NORTHERN BEACHES LOCAL PLANNING PANEL

WEDNESDAY 21 FEBRUARY 2024

4.0	PUBLIC MEETING ITEMS	5
4.1	DA2023/0368 - 1/9-15 Central Avenue, MANLY - Fit out and use of the courtyard for the seating of 100 patrons, operating from 8.00am to 10.00pm.....	5

4.2	DA2023/0386 - 207-217 Pittwater Road, MANLY - Alterations and additions to the service station including an automatic car wash facility, a laundromat and signage.....	24

Figure 2 - Shadow Study prepared by Jan Ellis

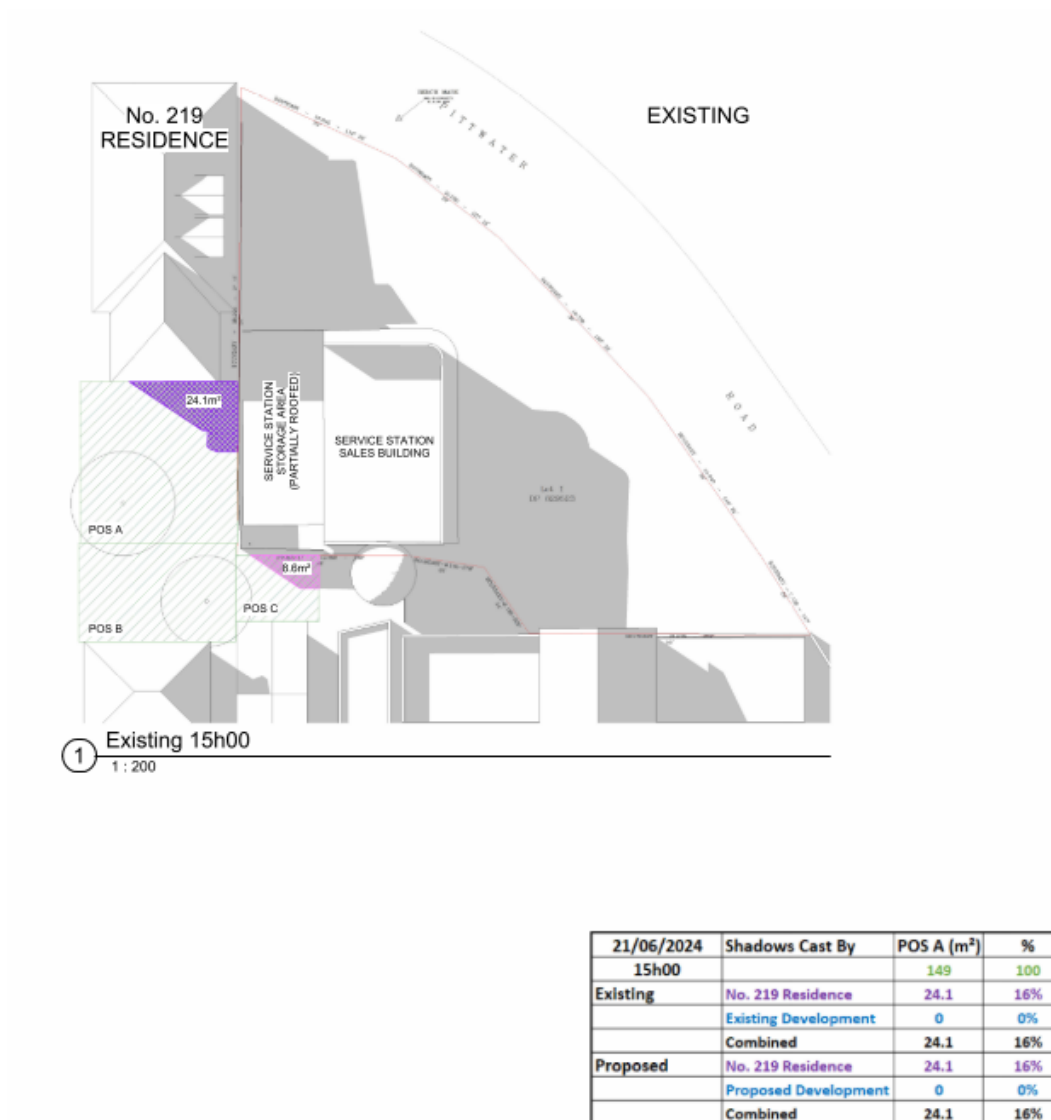
The submission(s) raised concerns that solar diagrams reinforced the impact of the proposed development on adjoining residential properties, in particular No. 4 Golf Parade, Manly and that no solar access assessment of the proposed development was completed for No. 2 Golf Parade, Manly.

Comment: The solar access assessment, conducted in accordance with Clause 3.4.1 Sunlight Access and Overshadowing of the MDCP, is comprehensively detailed in this assessment report. In summary, the assessment concludes that due to the height and insufficient side setbacks from the western and southern boundaries proposed by the carwash building, coupled with the location of private open spaces (especially at No. 4 Golf Parade), which will be in shadow from 9am through to 2pm during the winter solstice, the development falls short of providing adequate solar access to the adjoining residential property, as mandated by this DCP provision. It is further noted that No.2 Golf Parade is shaded by the existing service station during the winter solstice between the hours of 9 am - 3 pm.

Given this, it is deemed that this issue has been sufficiently addressed, and this identified deficiency will serve as a reason for the refusal of the proposed development.

Figure 4 - Land Zoning under Manly Local Environmental Plan 2013 of 207-217 Pittwater Road
MANLY **Figure 5 - Yellow highlighted portion above shows this area does form any part of the proposed development**

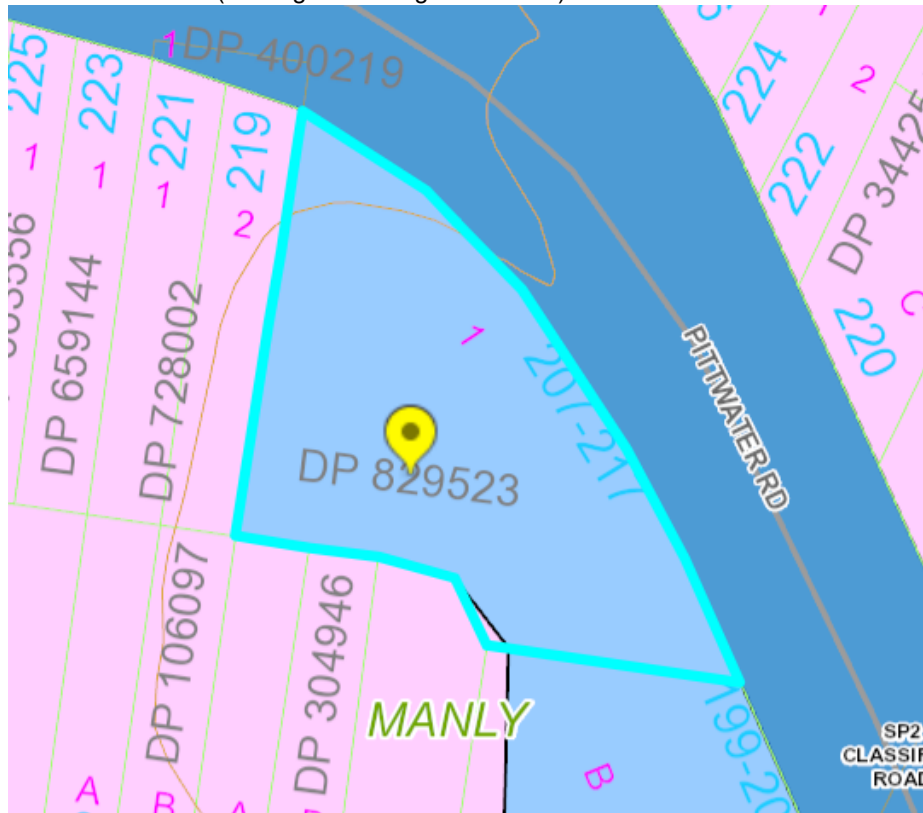
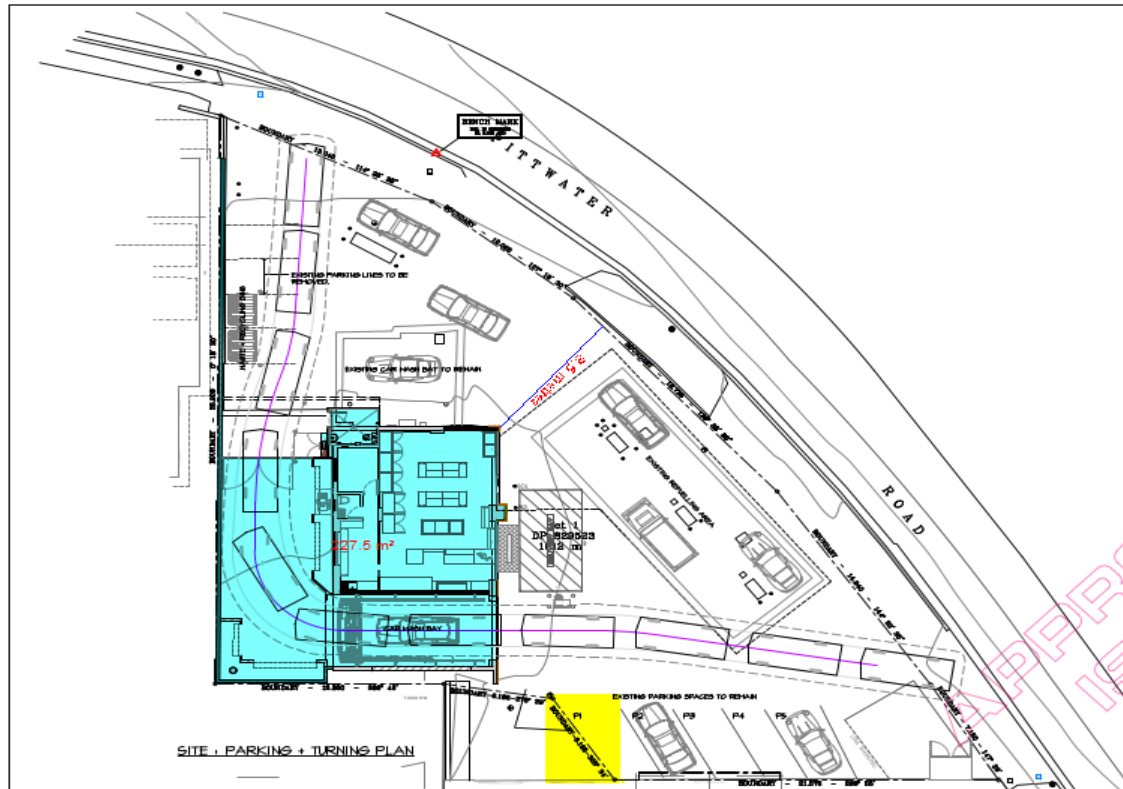
The subject site is zoned primarily E1 Local Centre under Manly Local Environmental Plan 2013 (MLEP 2013), however a small portion of the subject site to the west is zoned R1 General Residential under MLEP 2013 (see Figure 1 & Figure 2 below).

The proposal is for the alterations and additions to the service station including an automatic car wash facility and a laundromat that is permitted with consent under MLEP 2013 in the E1 Local Centre zone however is not a suite of permissible development under the R1 General Residential zone of the MLEP 2013.

Figure 6 - Overshadowing of private open spaces at 9am (Existing versus Proposed)

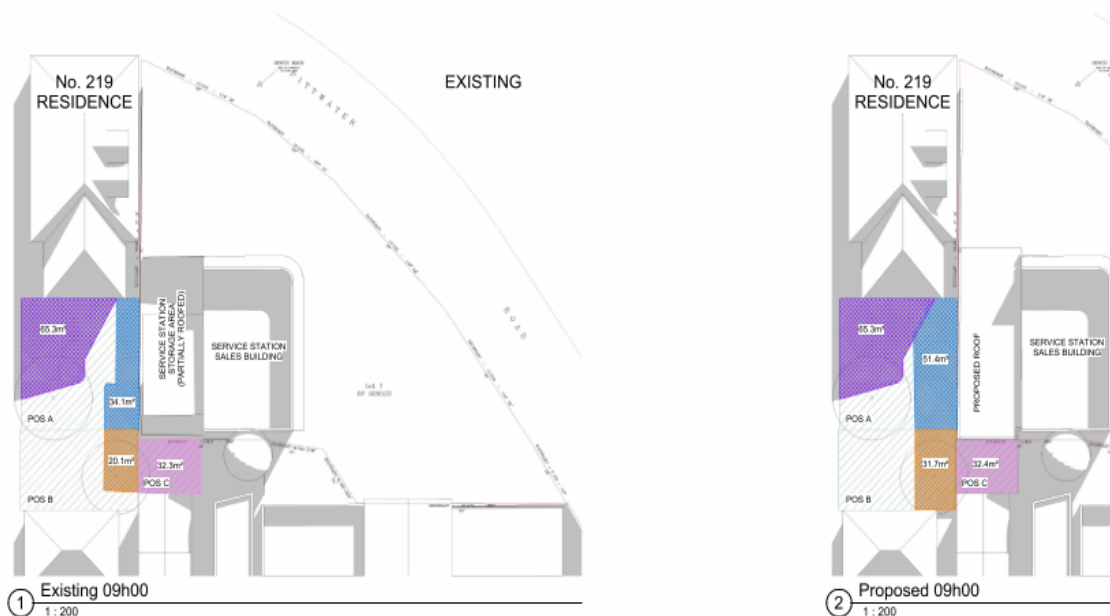
The proposed development, given its proximity to the southern side boundary, building height, and the difference in levels between the subject site and No. 4 Golf Parade (approximately 0.5 meters lower), has resulted in the overshadowing of the private open space of No. 4 Golf Parade, during the winter solstice, as indicated by the solar access diagrams submitted by the applicant, the private open space at No. 4 Golf Parade will experience overshadowing from 9 am to 2 pm.

This overshadowing creates a significant impact by depriving No. 4 Golf Parade of adequate solar access to their private open space area, diminishing the enjoyment and use of their private open space. As a consequence, the proposed development fails to comply with this objective, which emphasises the importance of preserving solar access for neighboring properties during critical periods like the winter solstice.

Figure 8 - Overshadowing of private open spaces at 3pm (Existing versus Proposed) including solar assessment of No. 4 Golf Parade demonstrating that the proposal will solar the private open from 9am to 2pm during the winter solstice.

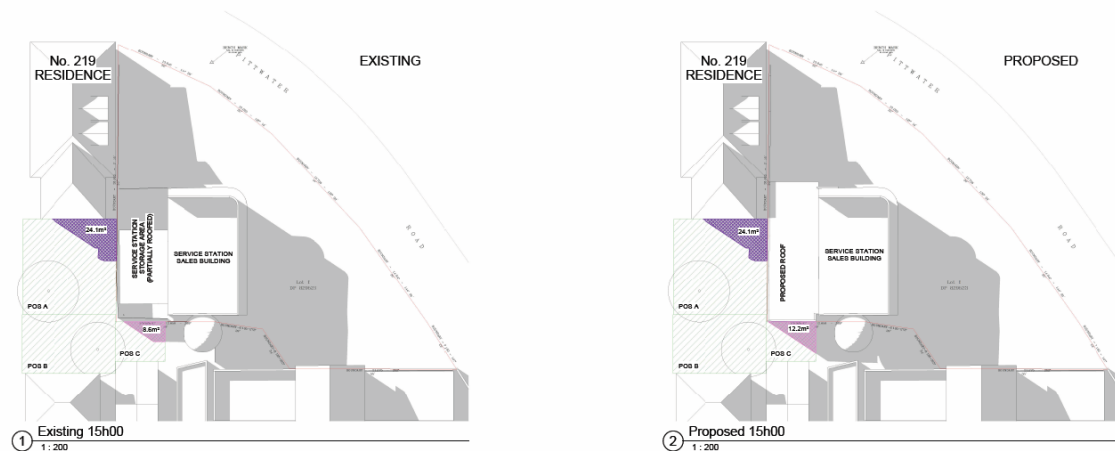
Solar assessment on 4 Golf Parade Manly
 POS = 32.4sqm
 9am (32.4sqm in shadow) = 100%
 12pm (25.6sqm in shadow) = 79%
 1pm (21.1sqm in shadow) = 65.1%
 2pm (16.6sqm in shadow) = 51.2%
 3pm (12.2sqm in shadow) = 38%

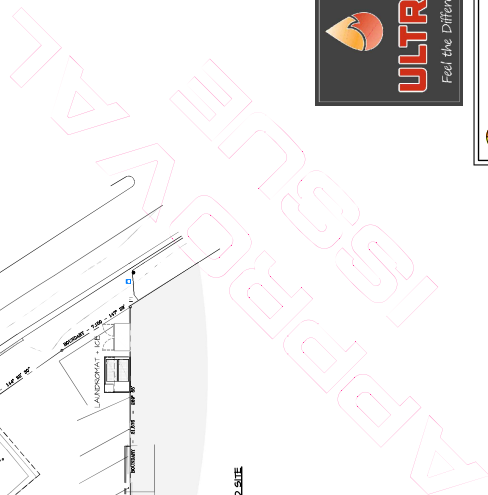
The proposal fails to provide adequate side setbacks, particularly along the southern and western sides adjacent to the carwash building. These setbacks are crucial for accommodating substantial landscaping, which plays a key role in softening the building's appearance and mitigating its visual dominance. Additionally, the proposal lacks sufficient measures to provide visual relief to neighboring residential properties, indicating a need for further consideration in the design to address these concerns.

Image 1 - Approved building footprint (DA2023/0192 building footprint)

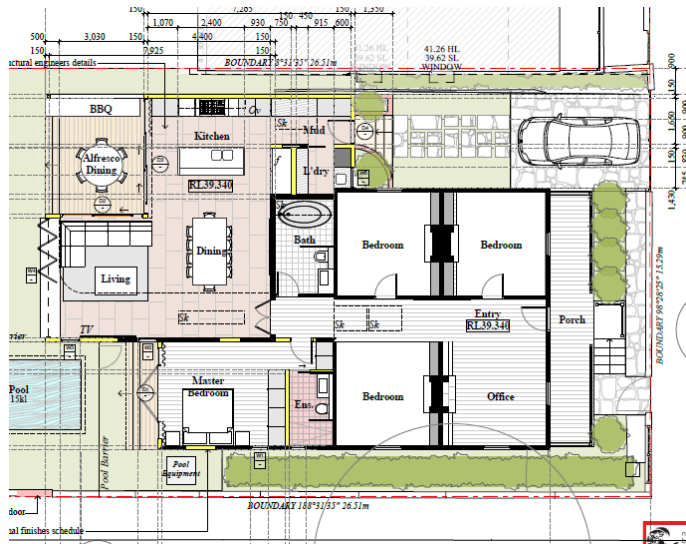
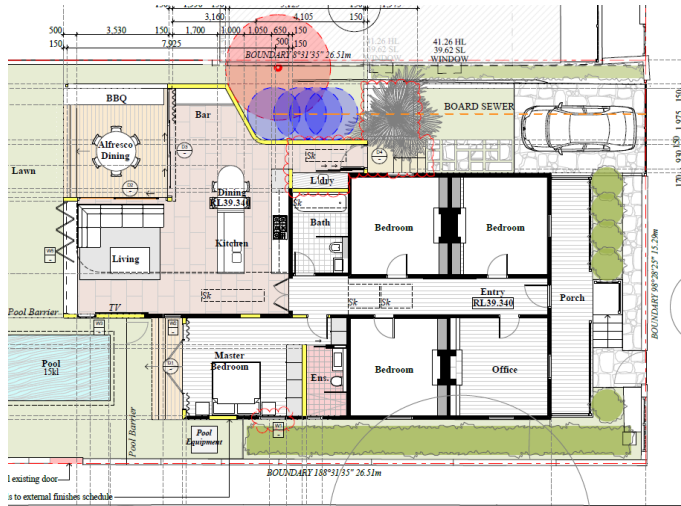
- Modification of the layout of the kitchen and dining spaces with the inclusion of a bar.
- Modification of the bathroom, laundry and entry to reduce size.
- Demolition of existing bathroom wall.
- Exclusion of the mudroom.
- Modification to entry stairs.
- Stormwater management alterations. The amendment to the stormwater management plan will require the amendment of Condition 7 and Condition 14. These changes are detailed in the conditions below.
